OREGON TECH

PROJECT CONSISTS OF INTERIOR RENOVATIONS & SITEWORK INTENDED FOR USE AS MENTAL AND BEHAVHIORAL HEALTH CLINIC.

- A. DATE: April 15, 2024
- B. PROJECT: OIT Applied Behavioral Analysis Clinic
- C. PROJECT NUMBER: 23020
- 1.02 TO: PROSPECTIVE BIDDERS:
 - A. This Addendum forms a part of the Contract Documents and modifies the Bidding Documents dated March 22, 2024, with amendments and additions noted below and specifications sections and drawings enclosed or attached.

- PART 2 AMENDMENTS AND ADDITIONS
- 2.01 CLARIFYING QUESTIONS:
 - A. See responses to Bid #2024-02 Clarifying Questions 1.
- 2.02 CHANGES TO THE DRAWINGS:

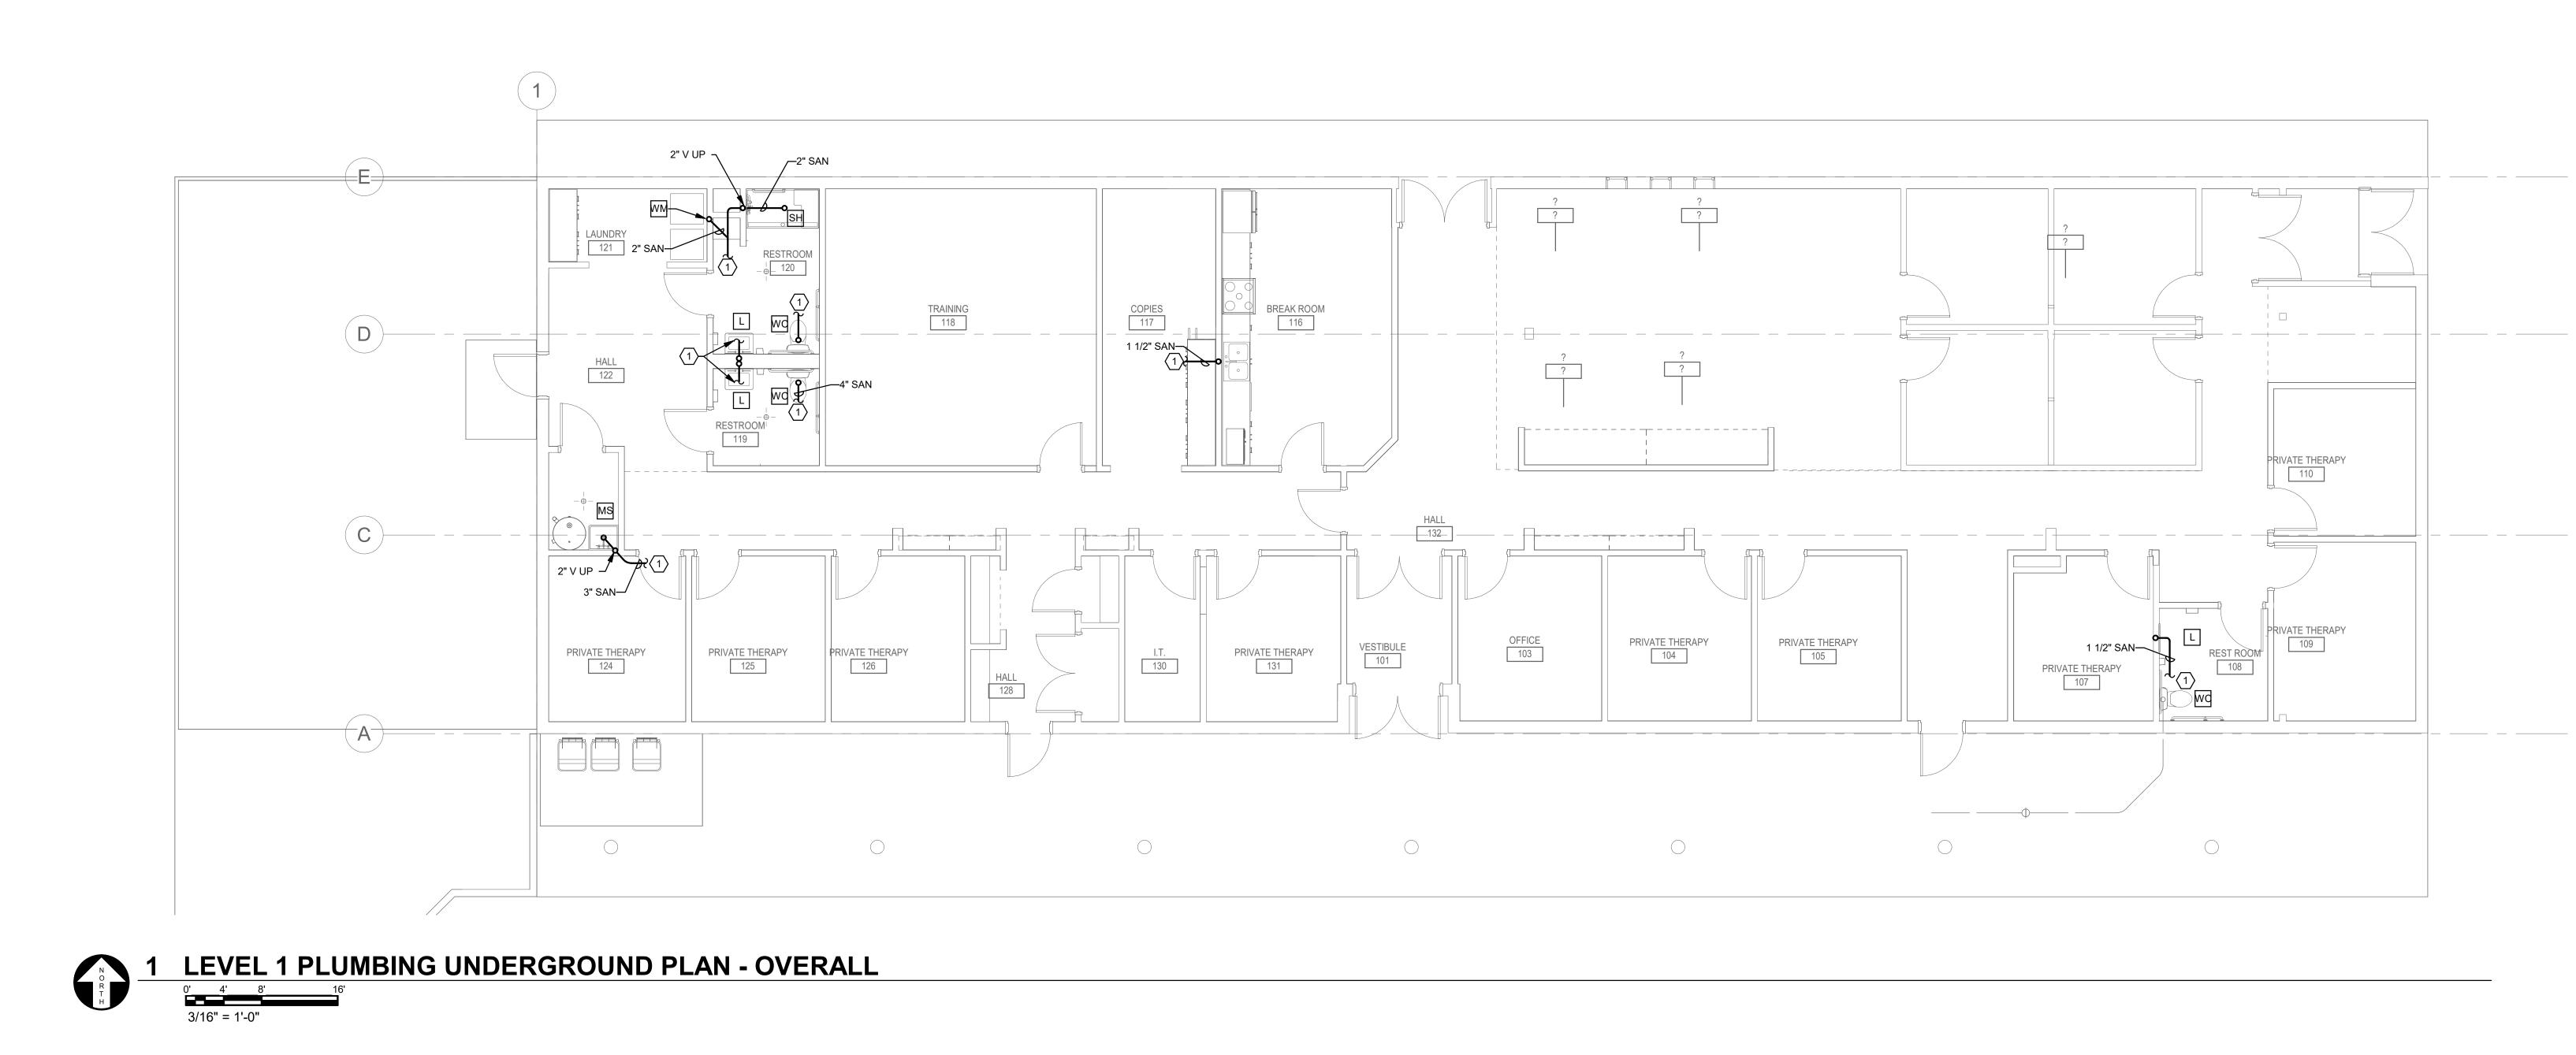
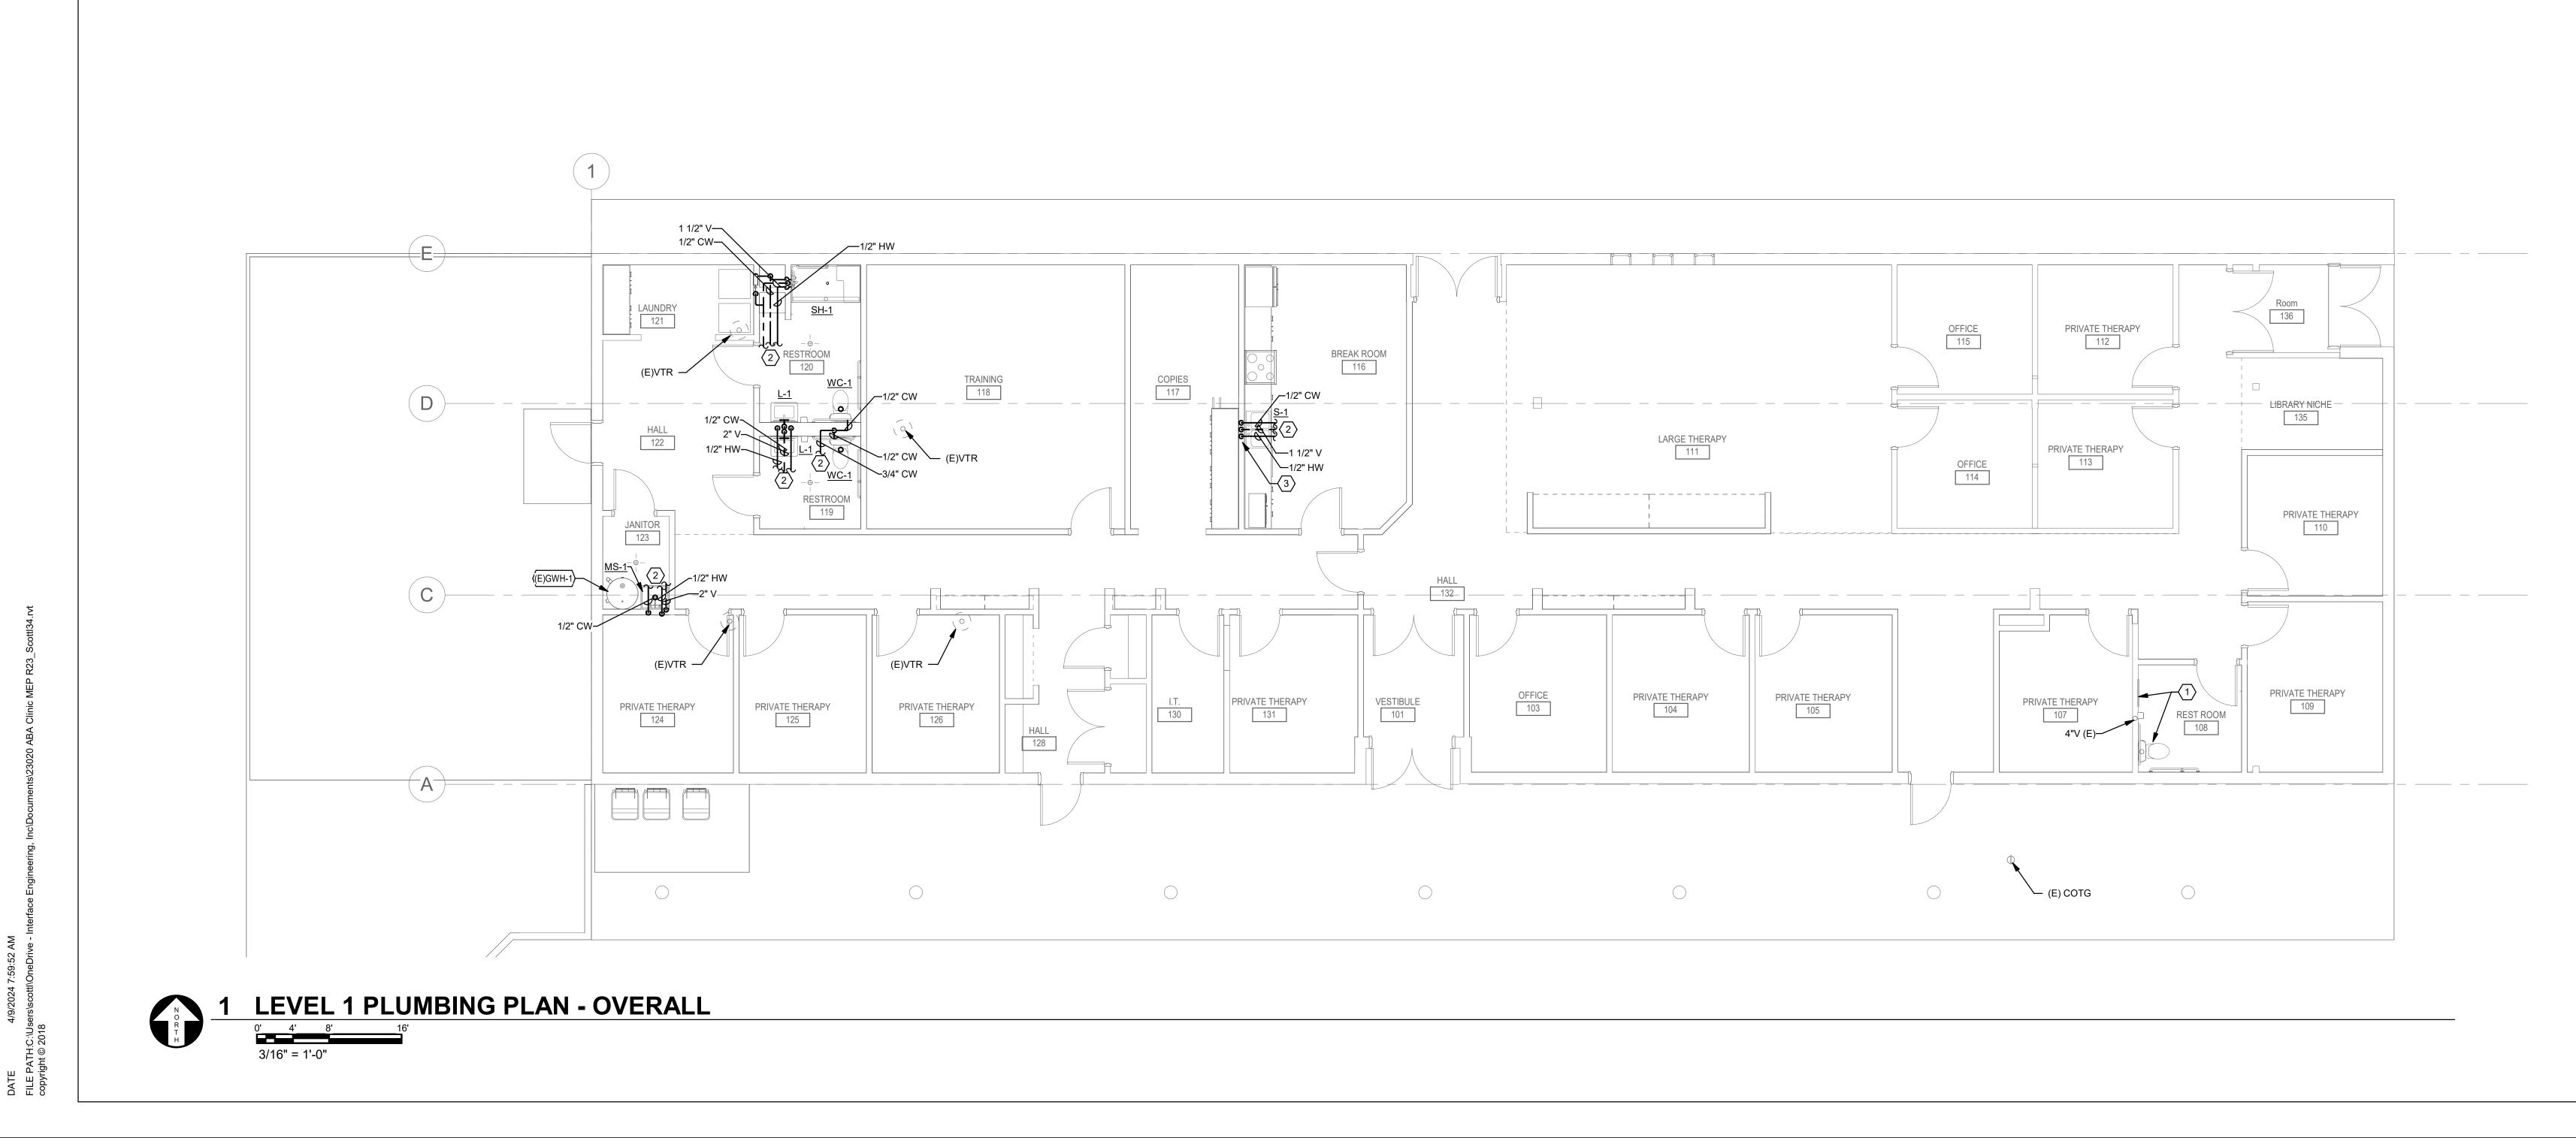
- D. PLUMBING DRAWINGS
 - 1. **Revise** Sheets P002, P200, P201 per attached.
 - a. Notes about fixtures and sanitary piping in Restroom 108 updated.
